Form 3160-5 (June 2015) UNITED STATES DEPARTMENT OF THE INTERIOR BUREAU OF LAND MANAGEMENT OF ISCOL FORM APPROVED OMB NO. 1004-0137 BUREAU OF LAND MANAGEMENT						O. 1004-0137
	UREAU OF LAND MANA NOTICES AND REPO is form for proposals to II. Use form 3160-3 (API	GEMENT RTS ON WI drill or to re	al ISD ad ELLS -enter an CI		MMM88139	
abandoned we	II. Use form 3160-3 (API	D) for such p	proposals.			
SUBMIT IN	TRIPLICATE - Other inst	tructions on	page 2			ement, Name and/or No. 35-262d Com

#### OXY USA Inc. - Corral Fly 35-26 Federal Com 34H, 35H, 36H – Amended Drill Plan

This is a bulk sundry request for three wells on a single pad. The wells related to this sundry request are:

# 5M BOP Stack

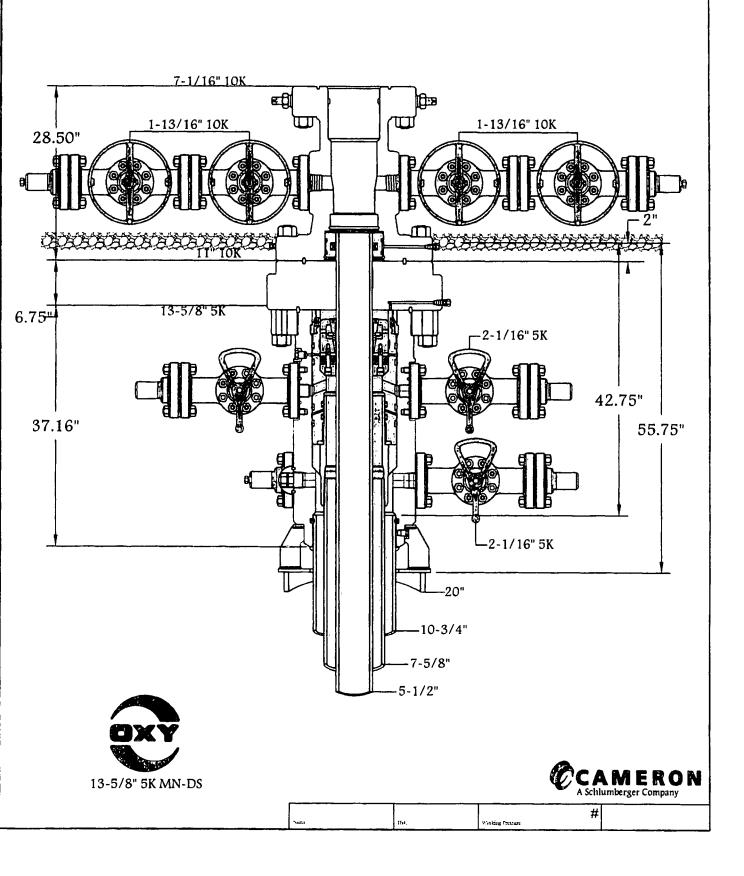
3. Amend the pressure control equipment due to casing size changes, see attached.
